# Notice of Allowability

10/621,317

DESAI ET AL.

**FIG. 4**

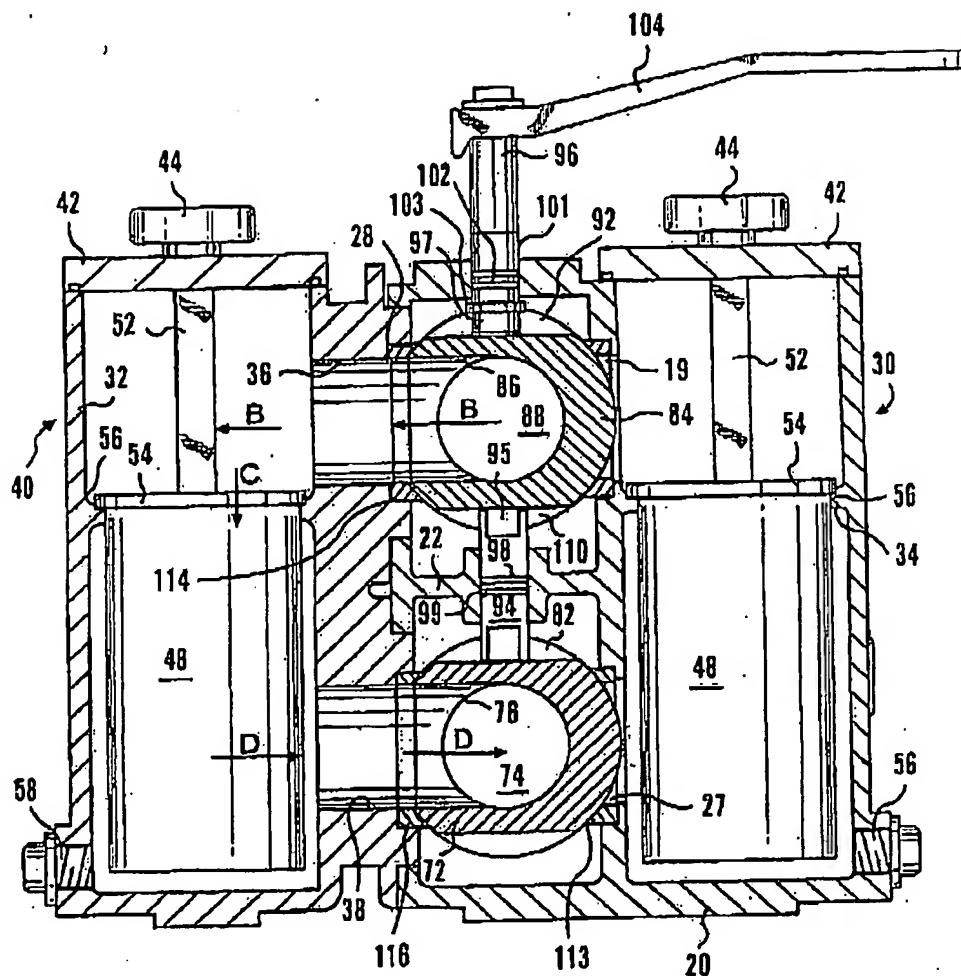
The amended paragraph beginning at column 4, line 37 of the specification filed on 9-2-08 has amended to replace the double brackets and strike-through with single brackets as follows:

-- Reference is made to FIG. 4 wherein three-way ball valve 84 is seated between a [left] seat 28 and a [right] seat 114. The second three-way ball valve 72 is seated between [an left] a seat 116 and a [right] seat [112] 113. Removal of chamber assembly 40 allows on-site access to any one of seats 28, 112, 114 and 116. --.
